Vineway Limited
Via email

WWLA1147

Delmore Subdivision: Response to Council's Questions Regarding Wetland Hydrology

Figure 1. Conceptual schematic of temporary culvert dewatering.

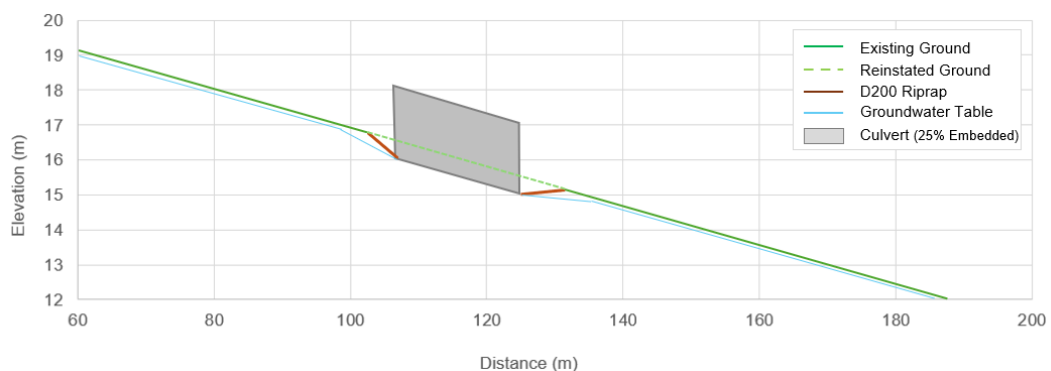
"Culvert design is unlikely to maintain hydrology across the entire width of some wetlands. Requires finer grained analysis as to its suitability from a hydro-geomorphologist. Some crossings may better suit realignments or bridging structure(s), with sufficient height above the wetland plants to maintain habitat viability.

Further analysis is required for culverts that impact or are immediately adjacent to wetlands e.g., Culverts 1, 3, 7, 9, 10."

As the channel is incised and flanked by higher elevation topography to both the north-west and south-eastern sides, the thalweg provides a control on groundwater levels (i.e., the water table is at, or near the surface, along the channel when groundwater levels are high (i.e., winter)). The installation of an embedded culvert will cause a temporary, localised lowering of the groundwater table, as illustrated by the schematic in **Figure 1**.

Using Culvert 1 as an example, the culvert will be embedded below the natural ground by ~0.5 m (25% of the 2.0 m high culvert). A 4.8 m long, D200 riprap apron will be installed at both the upstream and downstream ends of the culvert, tying back into the existing ground levels.

The embedded culvert will essentially create a localised drawdown either side of the culvert, lowering water levels by the embedment depth (0.5 m in this instance). Maximum drawdown will occur immediately upstream and downstream of the culvert, and decrease with increasing distance away, depending on the topographical profile upstream and downstream. This effect will only be temporary until a new natural bed has established within the culvert, tying back into natural ground (as illustrated by the 'Reinstated Ground' in **Figure 1**).
